**Flood Control Project Maintenance
Levee Inspections**

Maintenance Issue Types Only, Levee Inspection Report By Mile - Spring 2017

Reclamation District No. 0544 Upper Roberts Island

Waterway	Bank	Unit Miles	Inspection Start/End	Inspector
Unit No. 01 San Joaquin River	Left	6.05	04/05/2017 04/05/2017	Richard Willoughby

Photo 1 of 1 : SP_2017_RD0544_109_61_20170316_00048.jpg

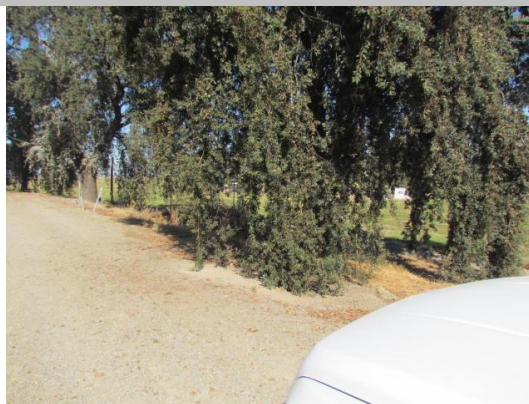
LM Start	2.28	Rating **	U	Issue No.	61
LM End	2.28	Issue Type +	Ma	Location *	LS
Category	Earthen Levee			GPS Latitude/Longitude	
				Start	End
Item	Trim / Thin Trees			37.821473 °	37.821473 °
				-121.346860 °	-121.346860 °
DWR ID	DWR_RD0544_02_s_2015_61				
Comment Code					
T1 : Trim trees to at least five feet above ground level.					
Inspector Comment					
Untrimmed tree on landward shoulder.

Looking west at untrimmed trees on landward slope fall 2015.

Photo 1 of 1 : SP_2017_RD0544_109_55_20170316_00044.jpg

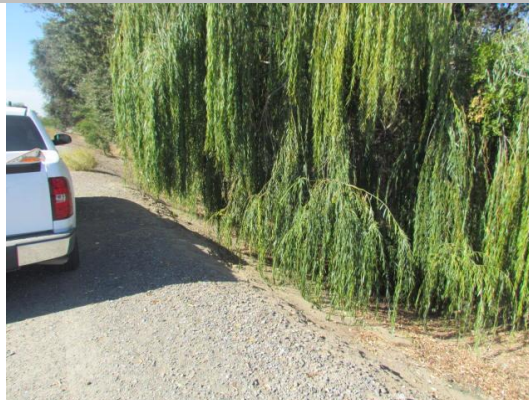
LM Start	3.49	Rating **	U	Issue No.	55
LM End	3.52	Issue Type +	Ma	Location *	LS
Category	Earthen Levee			GPS Latitude/Longitude	
				Start	End
Item	Trim / Thin Trees			37.819563 °	37.819542 °
				-121.364307 °	-121.364908 °
DWR ID	DWR_RD0544_02_f_2014_55				
Comment Code					
T2 : Thin trees to allow visibility of the ground and room to flood fight.					
Inspector Comment

Looking southwest at untrimmed trees on landward slope and toe fall 2015.
